**WATER RESOURCES INTEGRATION PROGRAM (WRIP) PHASE 2,
PUMP STATION IMPROVEMENTS
SAWS Job No. 16-8604
SAWS Solicitation No. CO-00339**

**ADDENDUM 1
6/30/2020**

S-1401

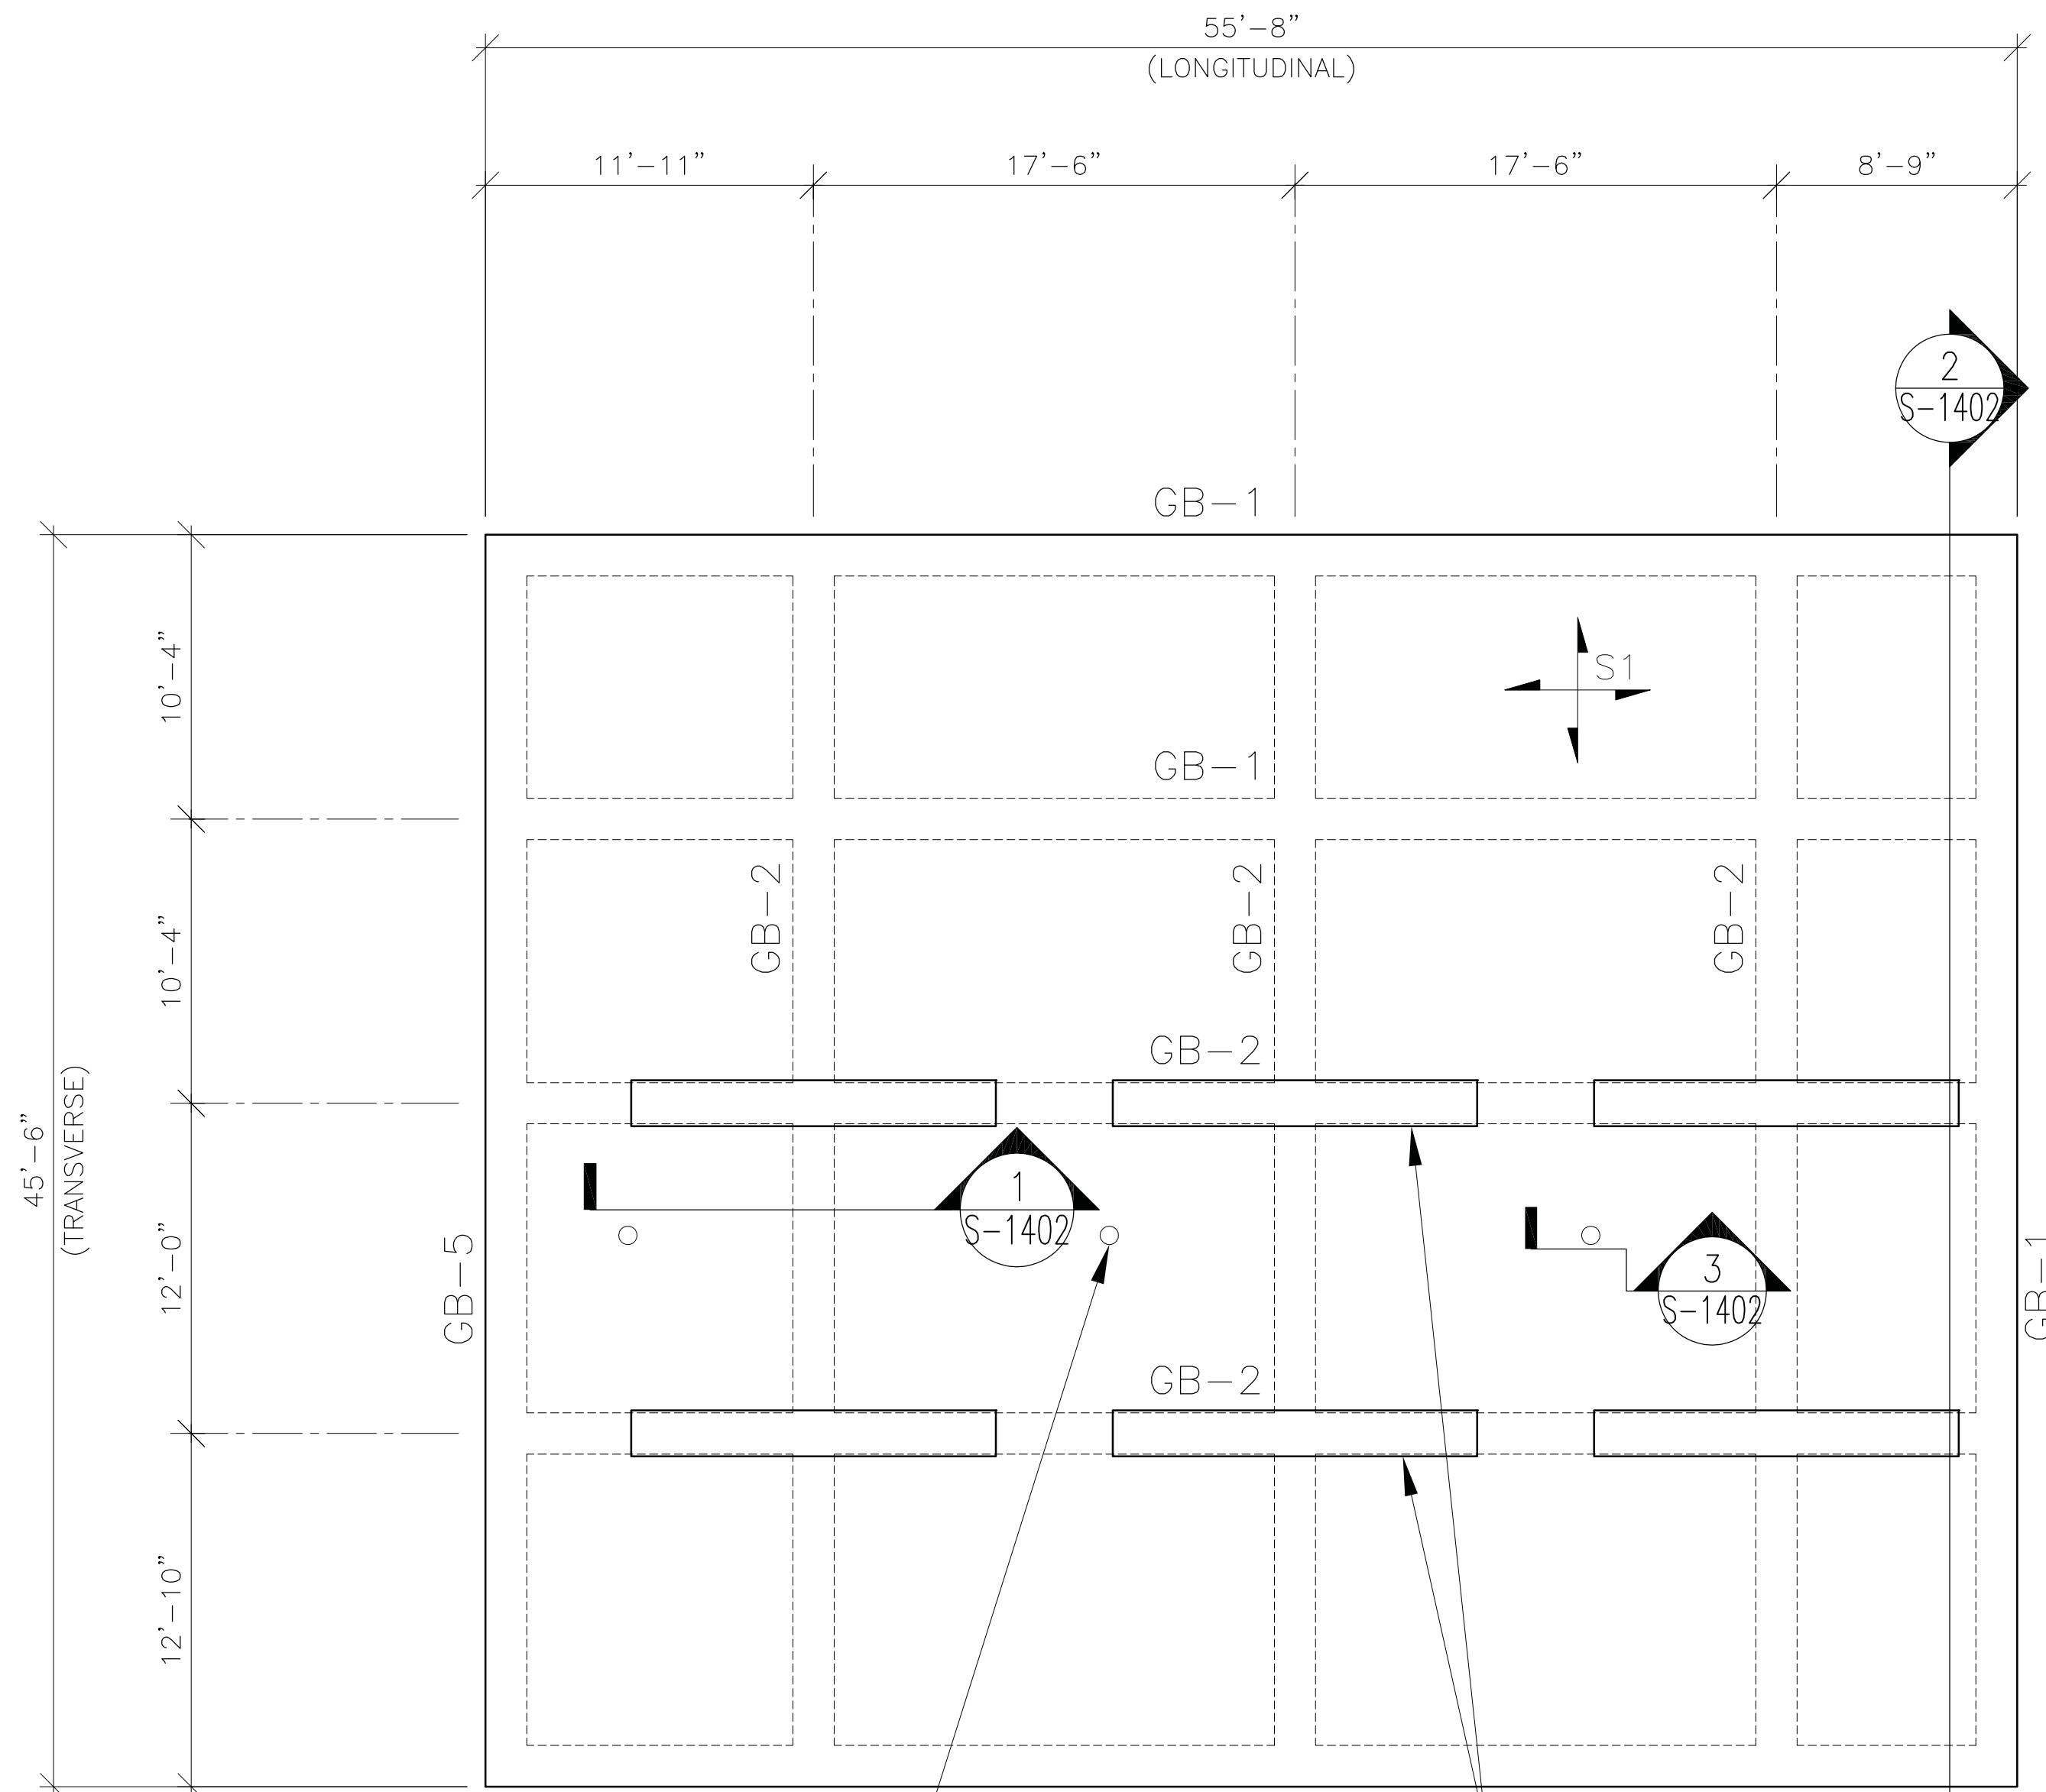
Drawing S-1401 – Surge Tank Foundation Plan

1. REMOVE and REPLACE in its entirety.

LOCATION OF STEEL SUPPORTS (TYPICAL)
